## FINAL DEVELOPMENT PLAN APPLICATION

RE: Project Science Blvd Franklin Peak  
Final Development Plan

**Date:** April 2, 2018  
**Re:** Franklin Peak - Science Blvd.  
Final Development Plan

### PLANNING AND DEVELOPMENT STAFF REPORT

EXISTING TREE SURVEY  
AND PRESERVATION  
PLAN

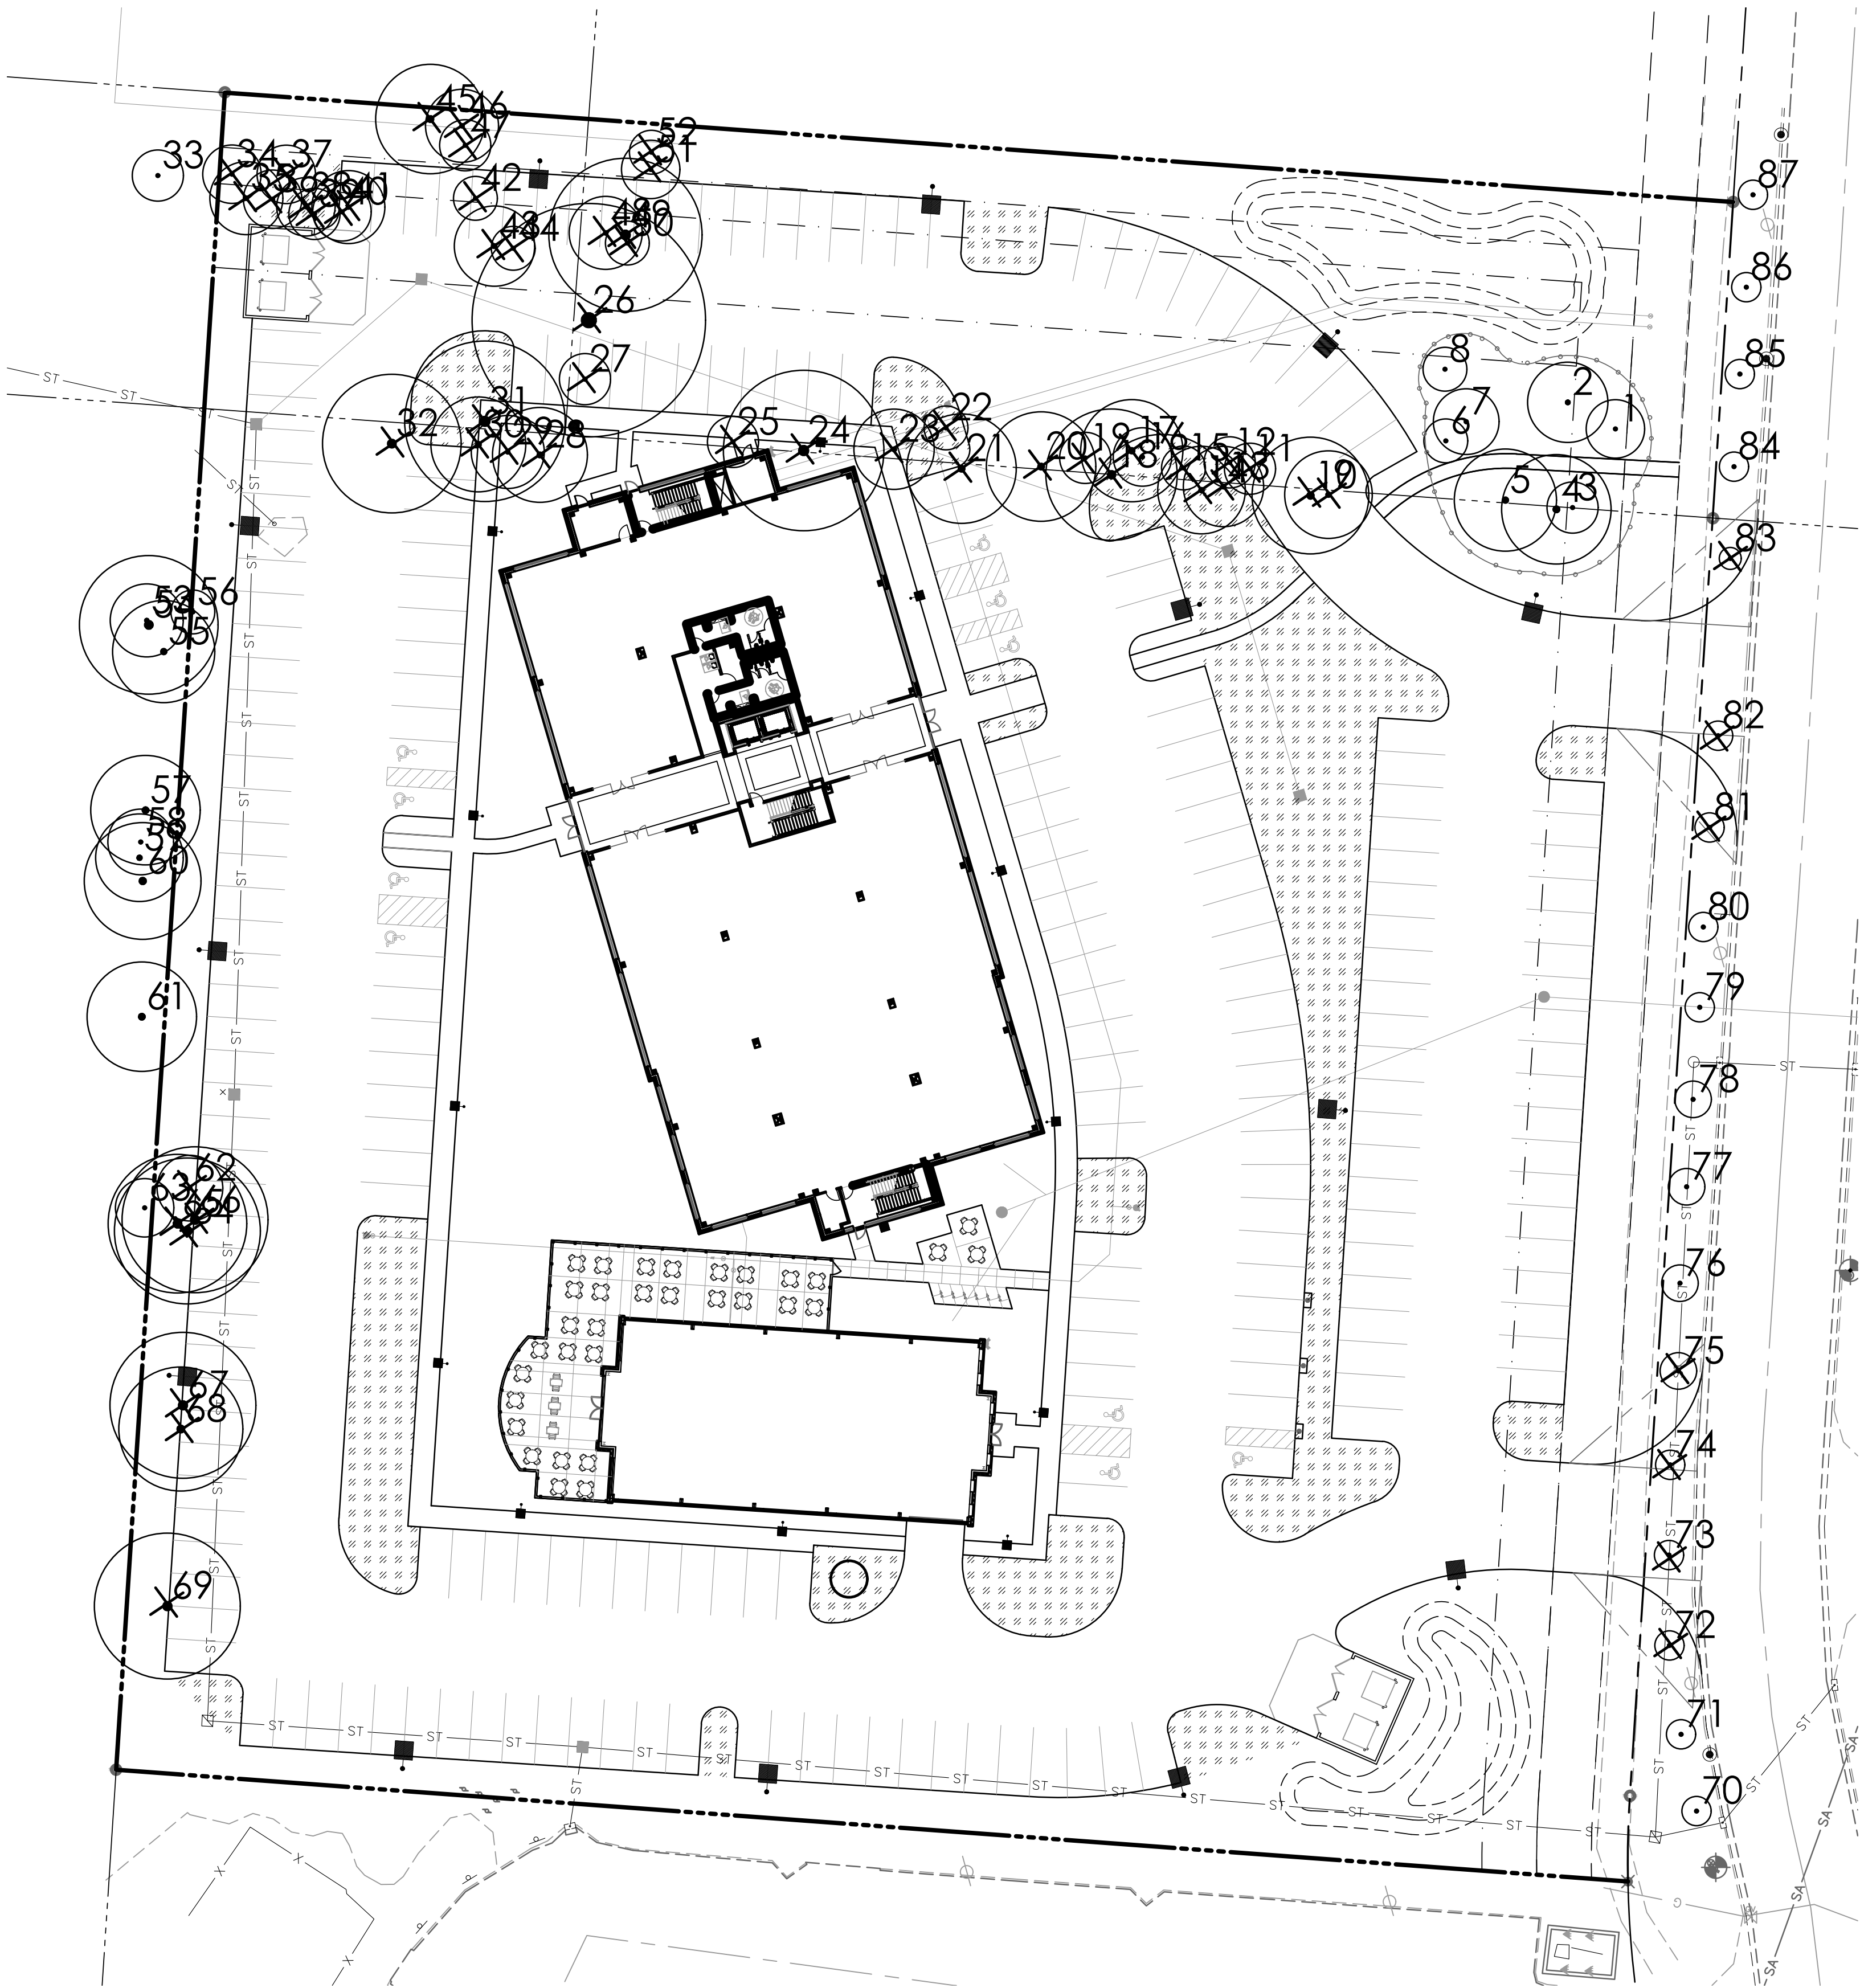
3. *I feel that this is over planted, and that will be an issue for the owner to deal with in the future. The other concerns that I saw was that the street trees are on the drawing but not listed as to what type of tree. The other concern is that we are keeping the site triangle open at the entrances? Per Rob Wendling*

**Existing street trees omitted in site triangles, of which the species is listed on sheet L-3. Tree calculations have been adjusted per Community Development response and site plantings have been reduced**
